KARACHI MUNICIPALITY.

REFERENCE No L.M.A.B.S.P 419 OF 1932

Order under Section 96 (2) of Act III of 1901.Mr. Pilornal S. Kerwan
c/o Mr K. T. Tuman

With reference to your application with plan for buildings on plot No. 18/2 Sheet No. 505, Janak Quarter submitted by you on 27. 8 1932, I have to inform you that the said plan is approved and permission to build in accordance therewith is hereby granted. The building must be erected in conformity with the Bye-laws and rules of the Karachi Municipality.

PLAN SHOWING THE PROPOSED
BUNGALOW ON PLOT NO. 18 J.M. 5
AMSHED QUARTER
SCALE 8-1 INCH.

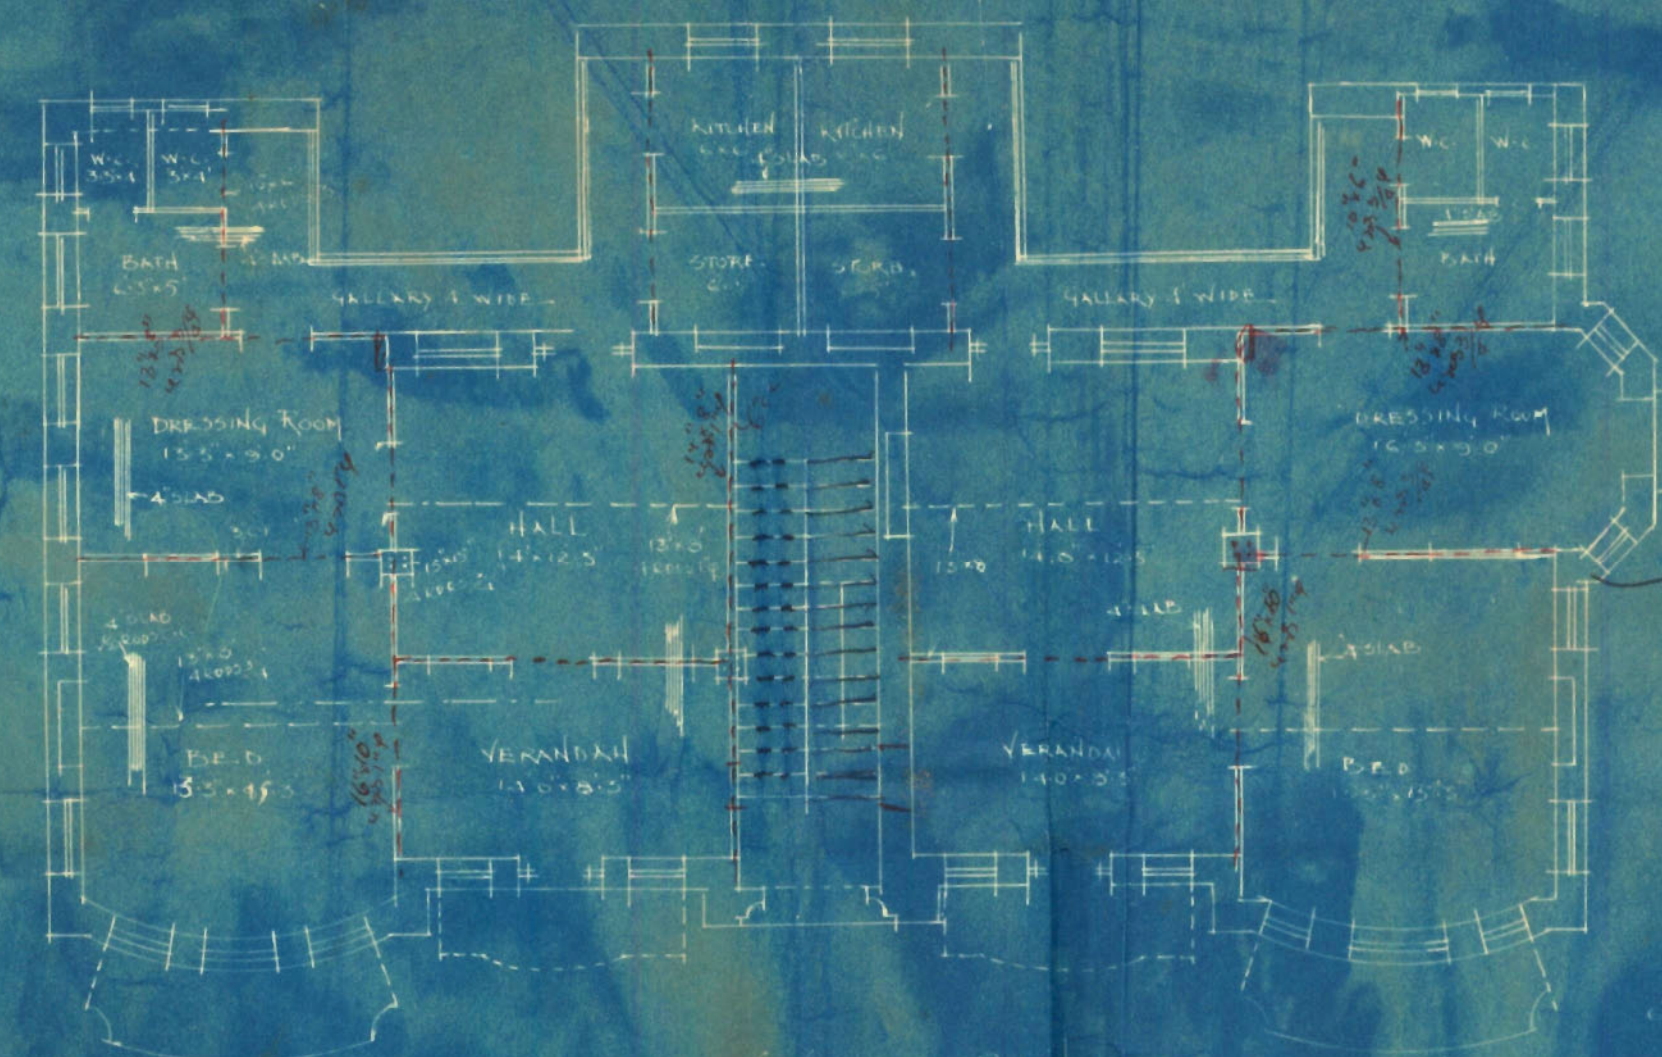
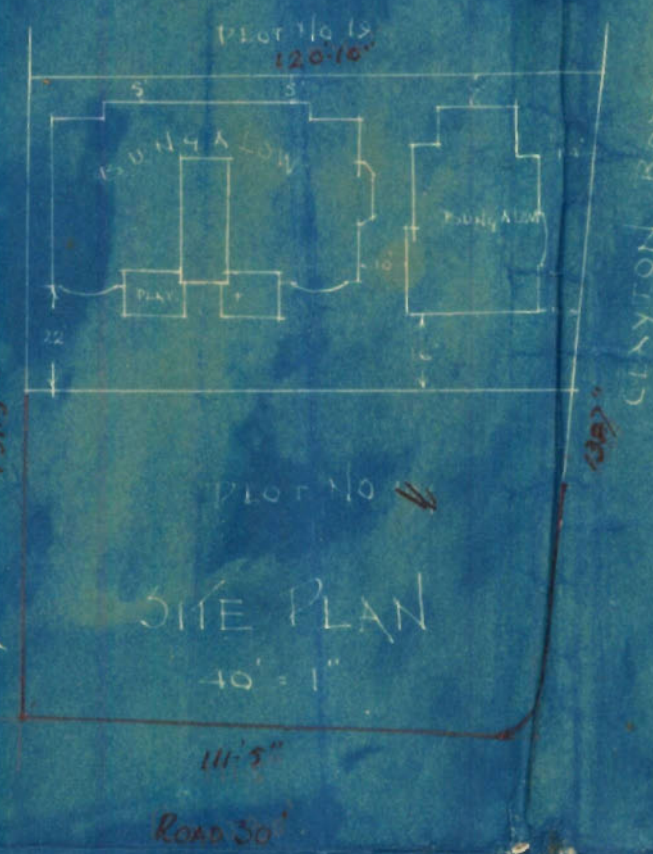
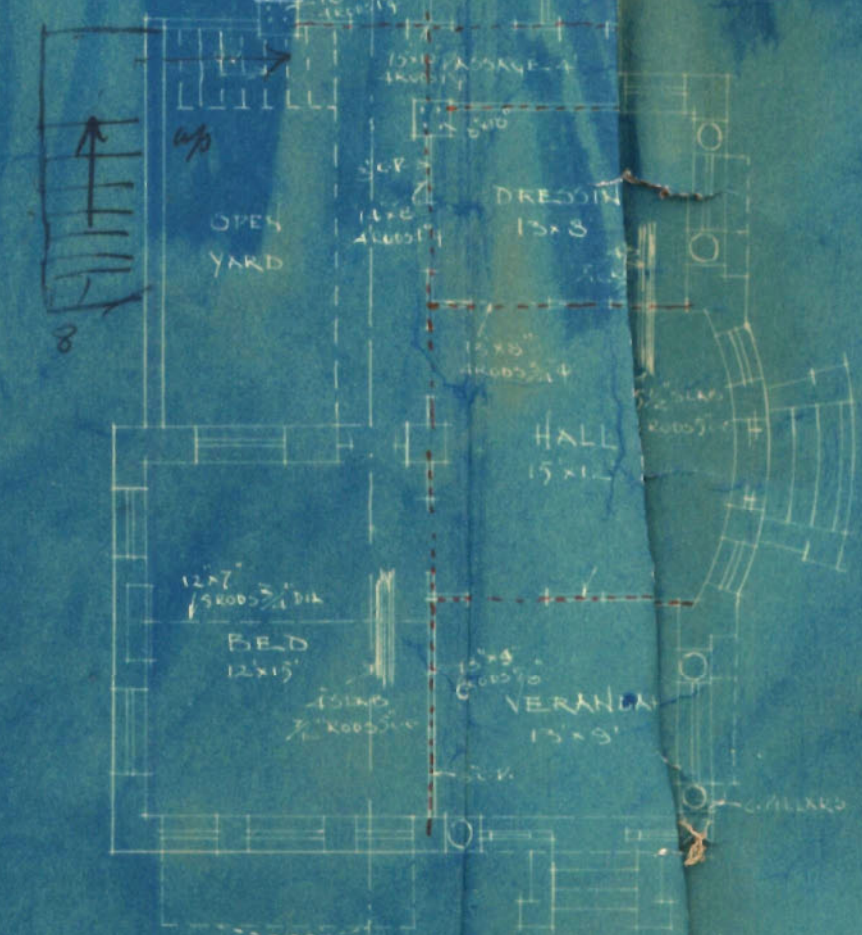
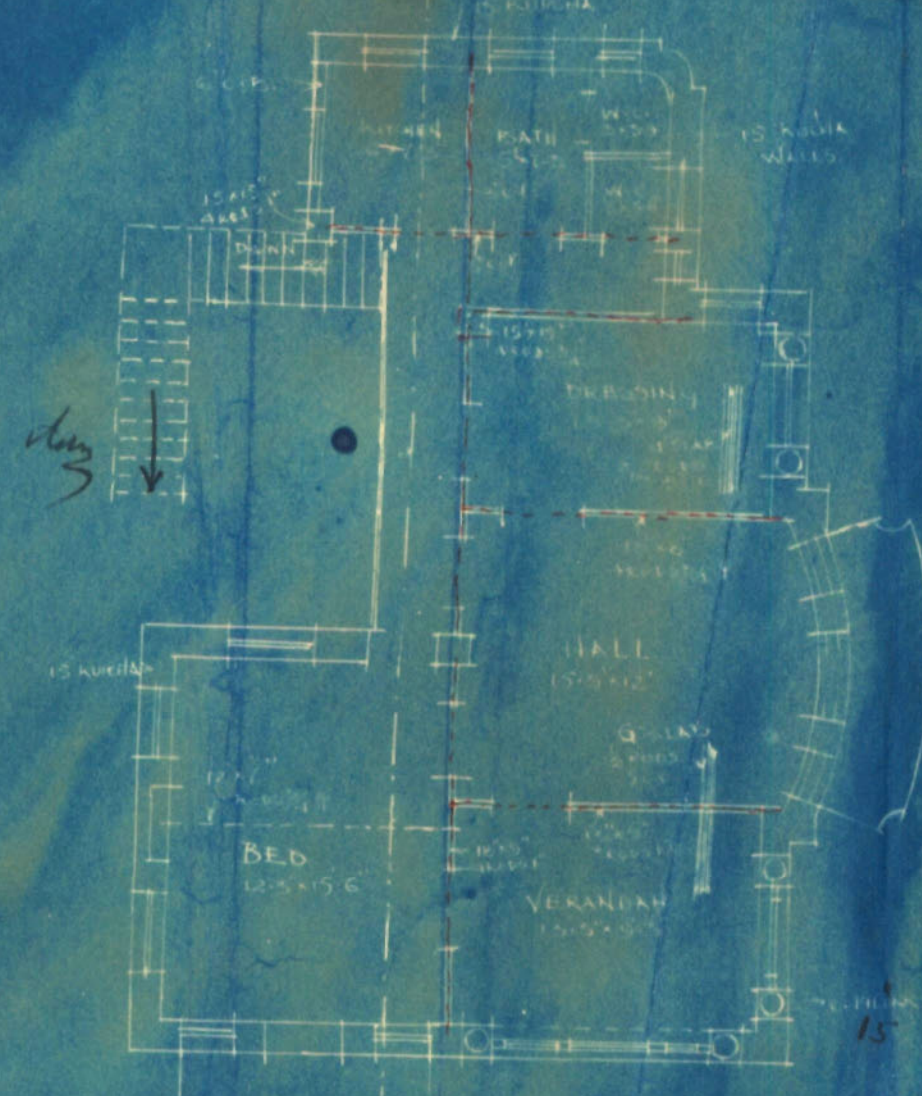
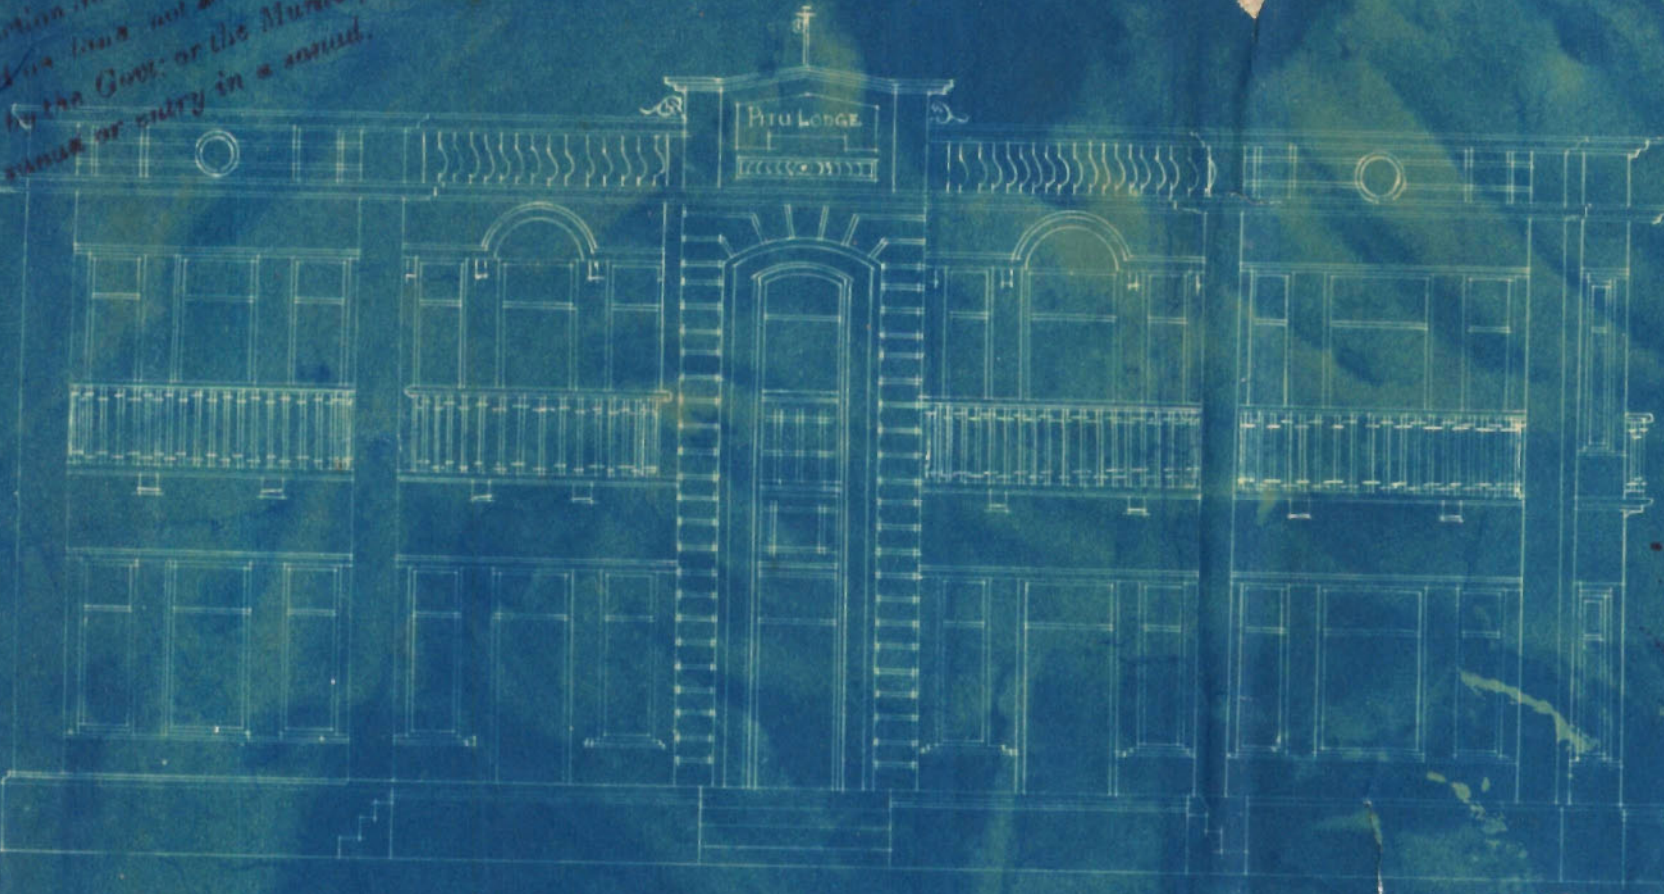
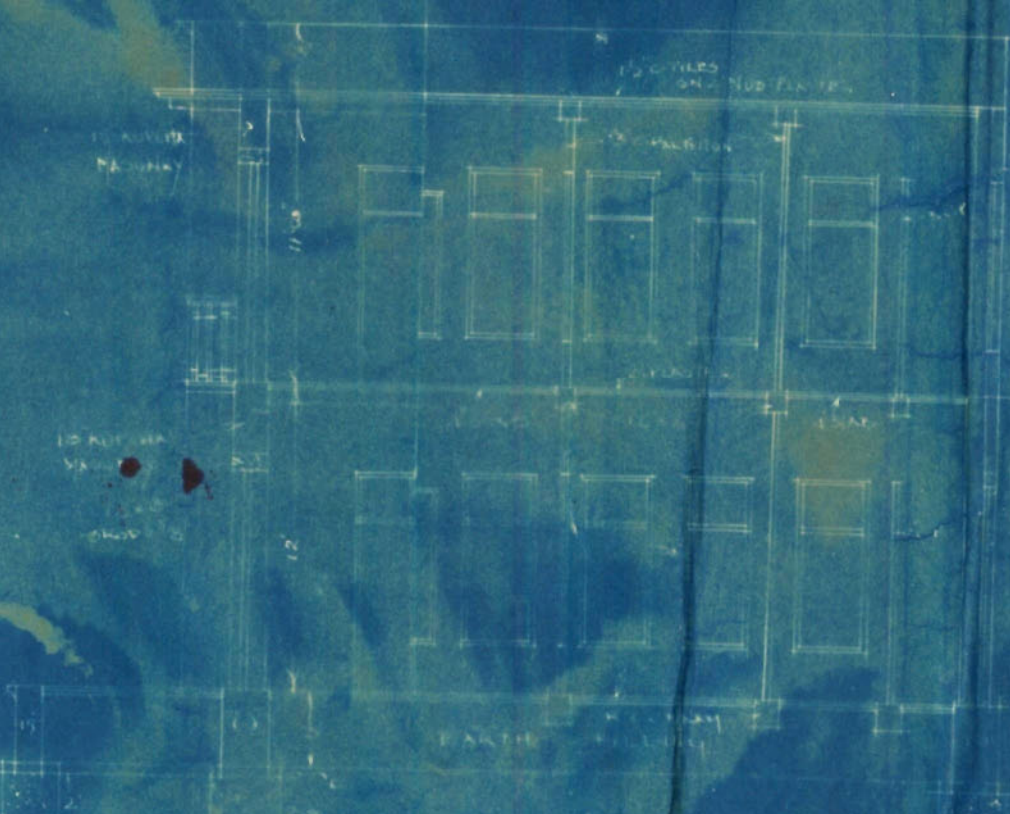
Remarks ① All the beams must be shown and

their dimensions, reinforcement etc. be given.

② Court Yard wall be kept 8' height and

not 10'.

③ Staircase to be fireproof

④ Pillar at the entrance as shown.

⑤ Balcony bracket should

be 4' maximum.

the plan must show a whole plan
and the signature of the owner is obtained

B8 & D8's O'ring. Central staircase should be covered as per
area built to be checked by planimeter. I Wall by the side of staircase
the 6" - Section of being a copy to give to the Sub-division
is not done.

Stair Case is allowed on ground floor only and is to be left open to sky.

Plans attached staircase is altered as per
only 1/2 is left after
to be.

All objections have been complied with. There is no necessity of subdivision as the H&S is shown as a whole. The area has been checked by planimeter and it comes practically correct. There remains the question of whether the stair case should be considered open or not. The orders are requested.
